APPLICATION NO.	FILING DATE	FIRST NAMED INVENTOR	ATTORNEY DOCKET NO.	CONFIRMATION NO.
10/597,205	07/17/2007	Carsten Heldberg	713-1429	7730

Office Action Summary	Application No. 10/597,205	Applicant(s) HELDBERG ET AL.	
	Examiner JONATHAN BRADFORD	Art Unit 3744

DETAILED ACTION

Annotated Figures**Saur**

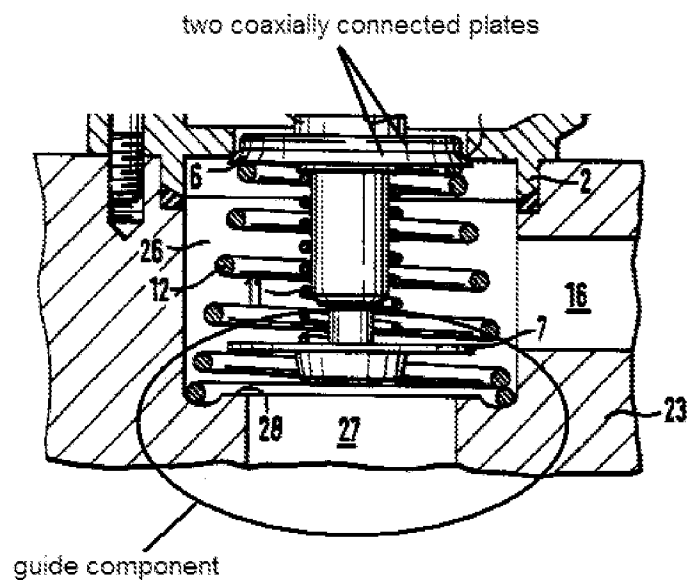
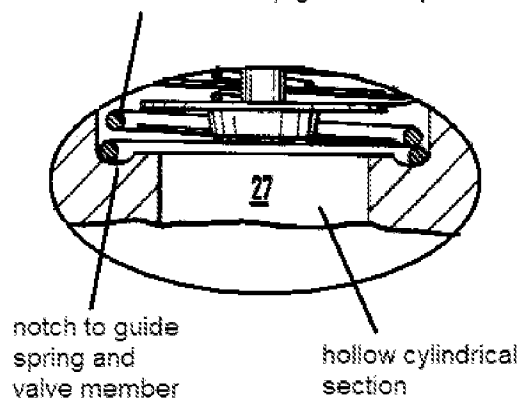
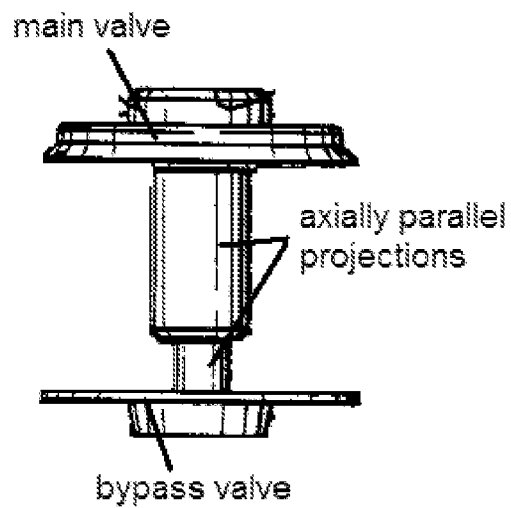
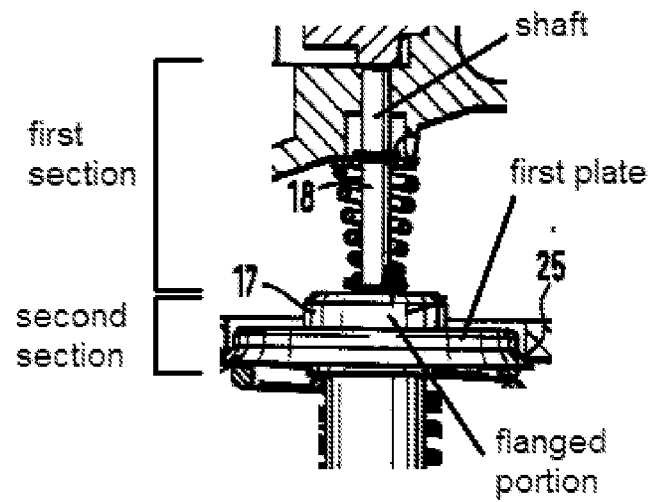
Saur does not explicitly teach that the main valve seat 25 is a conical valve seat. However, Henschel teaches a conical valve seat for a valve member (see annotated figures.) Since the main valve member 6 of Saur is of a conical shape, it would have been obvious to a person having ordinary skill in the art, at the time of the invention, to make the main valve seat 25 also be a conical shape similar to the valve seat of Henschel, because it would result in a larger sealing surface area between the valve 6 and the seat 25, resulting in a more effective seal that would be resistant to leakage..

As to claim 14, Saur, as modified, teaches an expansion element with a shaft 18 at the first section which faces the main valve seat, while a flanged second section is received in a complementary recess of the first plate (see annotated figures.)

As to claim 15, Saur, as modified, teaches a main valve member 6 which is connected to the bypass valve member 7 by parallel projections which extend axially (see annotated figures).

spring surrounding notch and cylindrical section which make up guide component

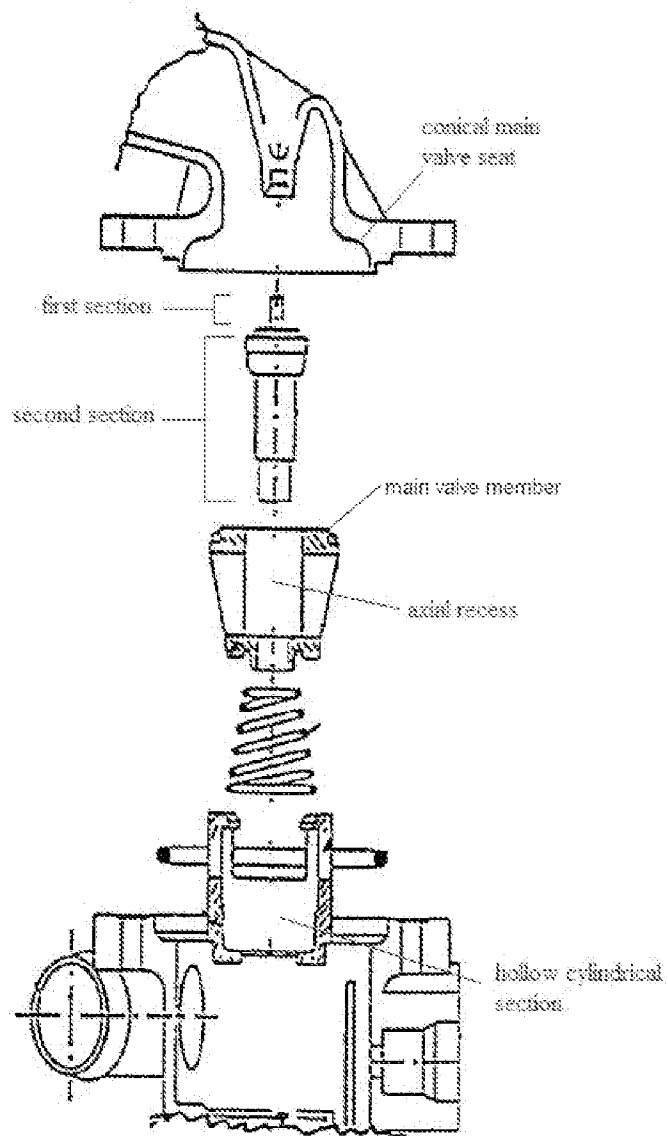
As to claim 29, Henschel, as modified, teaches a guide component 5 with an internal radial flange on which the valve spring 6 is directly supported (shown in Figs. 2 and 3 of Henschel). The flange projects outwardly from the center hole at the lower end of the guide component 5.

Henschel

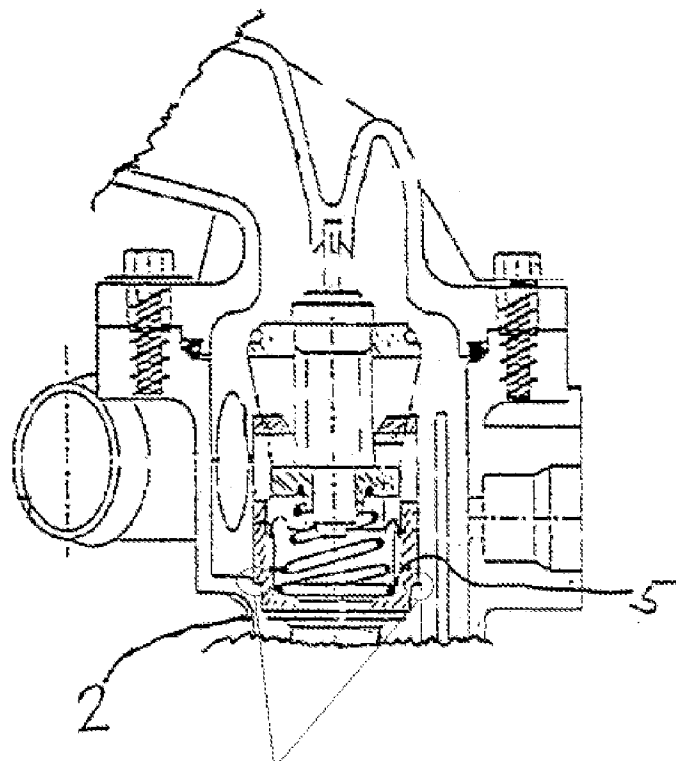
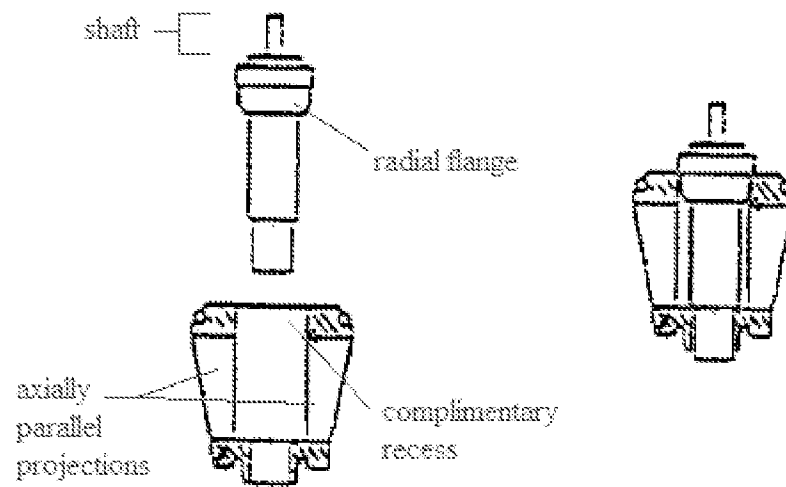
As to claim 30, Henschel teaches a guide component 5 that has an annular rib which fits securely into an annular groove of the lower portion 2 that supports the guide component (see annotated figures).

Annular rib of guide component 5 fits securely into an annular groove of the lower portion 2 which supports the guide component.
